# **Staff Report**

# Infill Housing Design Review Committee

File Number: 2-A-21-IH

Location: 1541 Minnesota Ave. Parcel ID 81 P E 024

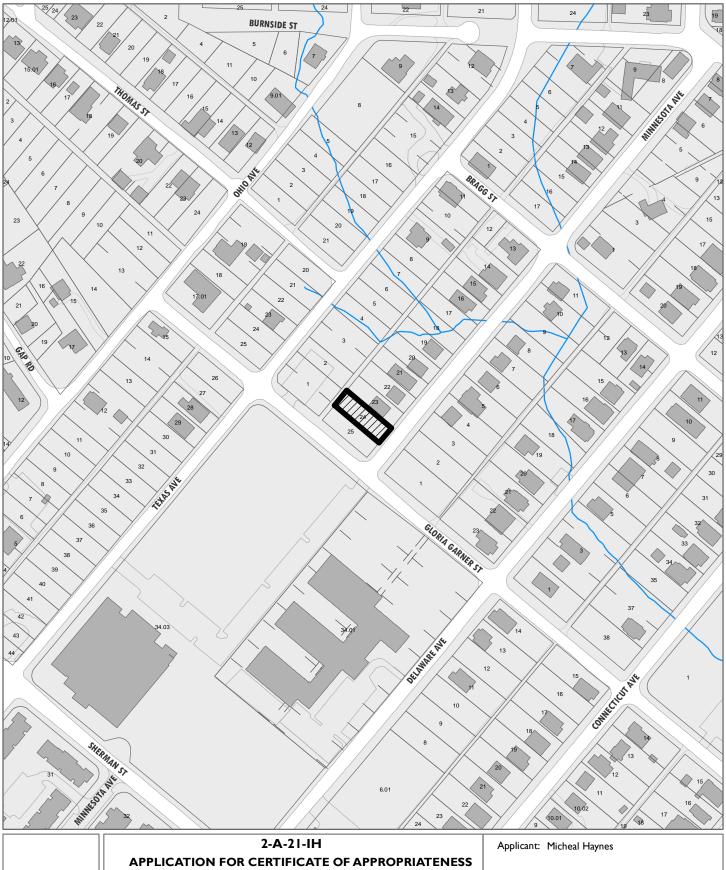
- 1. The proposed front setback of 20' to the full-length porch and 28' to the main massing of the house is compatible with the average front setback of 23.7' on the block. 1537 Minnesota Avenue, the adjacent new house reviewed in January 2020, will be in the same range. The site plan includes a walkway from the front door to the street.

- 2. The one-story, three-bay house is proportionate to the dimensions of the lot and the other houses on the block. The side yard setbacks are consistent with the block, where most houses are closer to the side property line to accommodate driveways.

- 3. The alley behind this block of Minnesota Avenue is not operable, so parking will need to extend off Minnesota Ave. The parking pad should be at least 20' behind the front façade of the house. Gravel or permeable pavers may be used to stay within impervious surface limits.

- 1) Parking should meet City Engineering requirements, be located at least 20' behind the house's front façade, and utilize gravel or permeable pavers as necessary to stay within impervious surface requirements;
- 2) Use a gable vent on the front gable field and clad the foundation in stucco;
- 3) Additional windows on the left elevation;
- 4) Meet City Homemaker requirements for visitability with a ramp or a zero-step entry on one elevation;
- 5) Final site plan should incorporate one native or naturalized shade tree in the front and rear yards.
